# King Street Road Work Update May 3, 2010

To Members of the Association and Others on the Mail List  
Update on the progress of King Street  
Remaining Questions on Design  
Communications with Town Officials

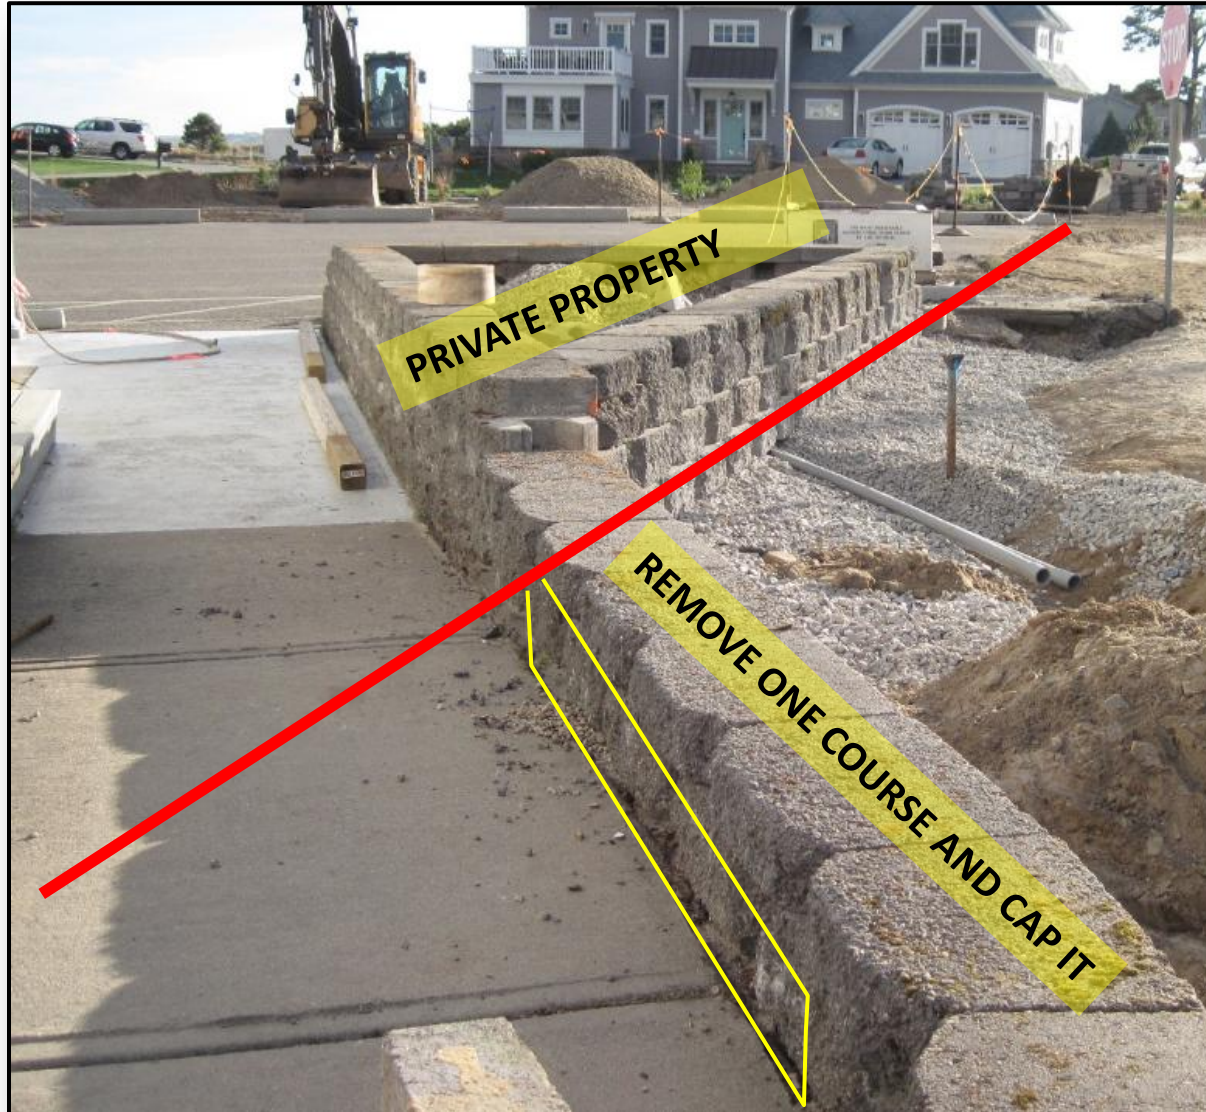
The stone wall structure encroachment has been removed from the other side of this driveway May 3, 2010 with the exception of these concrete blocks which presumably will be removed. Residents were informed that a curb will replace the perimeter of the former wall to define the property line and the travel way, with grass inside allowing pedestrian access once prevented by the stone structure.
